INDEPENDENT REVIEW

Retention & Redevelopment Options Study

SELKIRK HOUSE
LONDON BOROUGH OF CAMDEN

34006-HML-XX-XX-RP-V-790003

Points 2: NET ZERO: UK Legislative Context.

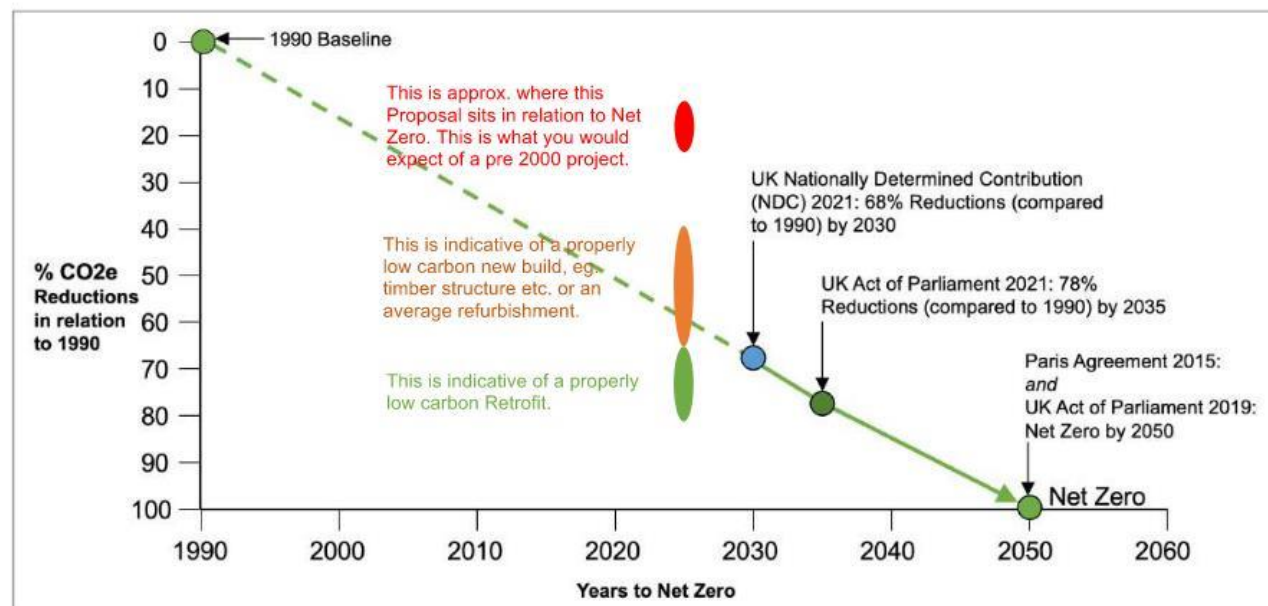
This diagram illustrates where the proposed new Museum St development sits in relation to the Governments 1990-2050 trajectory to Net Zero. Above the line is **BAD**, as you are performing worse than the trajectory, below the line is **GOOD**.

The proposed scheme exceeds UK legislative targets.

The concerns raised in this page of the SMS report are reasonable concerns and Camden should take them into consideration.

Diagram from Retention Options Review p10

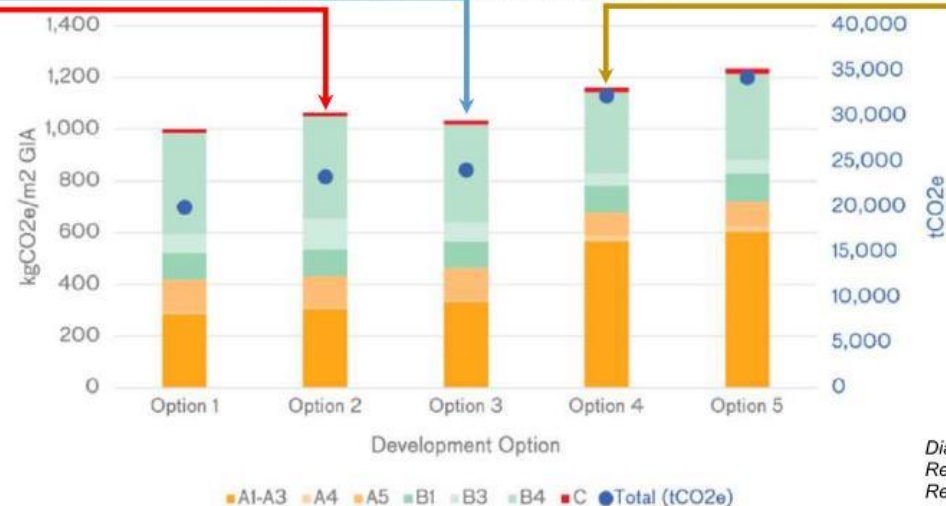
The Whole Life Carbon figure is 1294kgCO2e/m2.

This is a very high figure for a new commercial office building and suggests inefficient resource and carbon choices.

All carbon figures in the SMS report are now superseded.

Point 3: Floor to Ceiling heights:

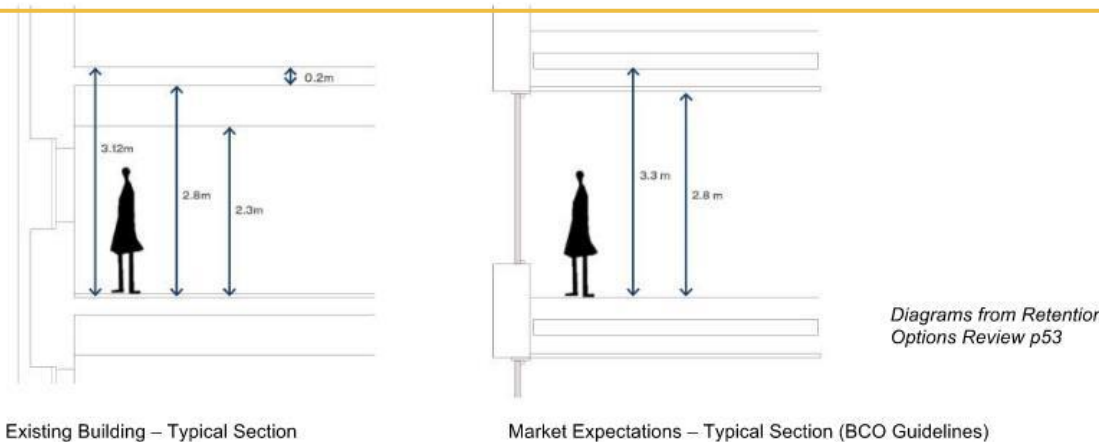
- These show local sections through the existing building (on the left) and through the proposed new build (on the right).
- The existing section shows a finished floor/ceiling height of 2.3m. This assumes a ceiling plus void of 500mm. This is excessive for offices, which today usually avoid ceilings and have exposed services. The BCO Guide allows for refurbishment floor to ceiling heights to be between 2.45m and 2.8m. This could meet this requirement with the right design solution. **Therefore, this is misleading.**
- The existing section overall floor to ceiling height of 2.8m, originally designed for office use (Trusthouse Forte) and then converted for hotel use, could now be residential or other use, particularly for Option 3 where the new floors/facade could include balconies. **The existing Floor to ceiling heights would be fine.**

Diagram from Retention Options Review p45

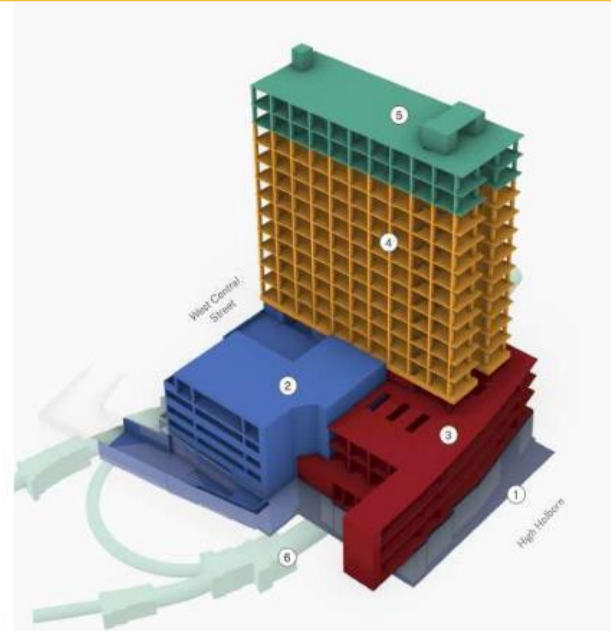
Much is made of the car park ramps (blue) as being a major reason for demolition. However as can be seen they do not cover the whole site, and therefore could have a limited impact even if demolition is required. What is required is positive and creative design intent for the use of these car park areas.

The car park is therefore not a determining factor for demolition.

This has been updated in the last version of the optioneering report.

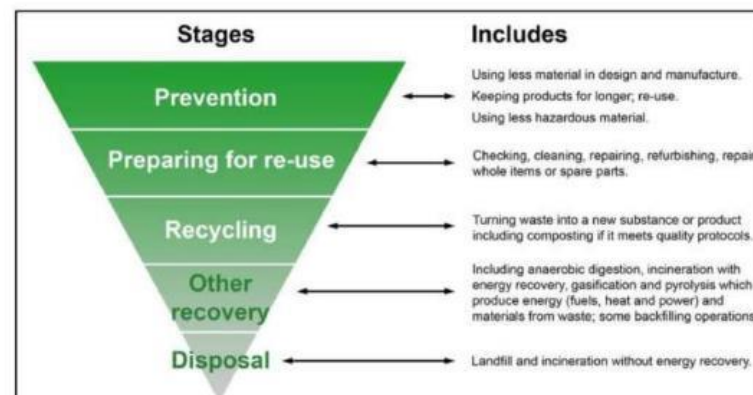
Aluminium, the majority facade material is NOT a local material, it is NOT responsibly or sustainably sourced, and will NOT reduce transport emissions.

There is no evidence for example to ensure that special measures have been taken with respect to the facade design to: 'optimise the chances of reusability and recoverability', or to 'maximise life cycle', or to 'ensure that it is as adaptable or flexible' as possible. What has been designed is a routine aluminium curtain walling facade solution. These claims should be conditioned.

The Circular Economy Statement (CES) for the site has been updated and re-submitted (rev. 10) as part of the new planning application (2023/2510/P), but most of the concerns raised in the SMS report are still valid points.

The updated CES (rev. 10) is not substantially different from the one presented as part of the previous planning application (rev. 05). A useful addition is the pre-reclamation audit report produced by HTS's structural engineers (Appendix D of the CES), which explores possible solutions for reuse of existing structural elements.

Everything in the CES is still presented as a possibility, there is no clear commitment towards specific circular economy measures / actions.
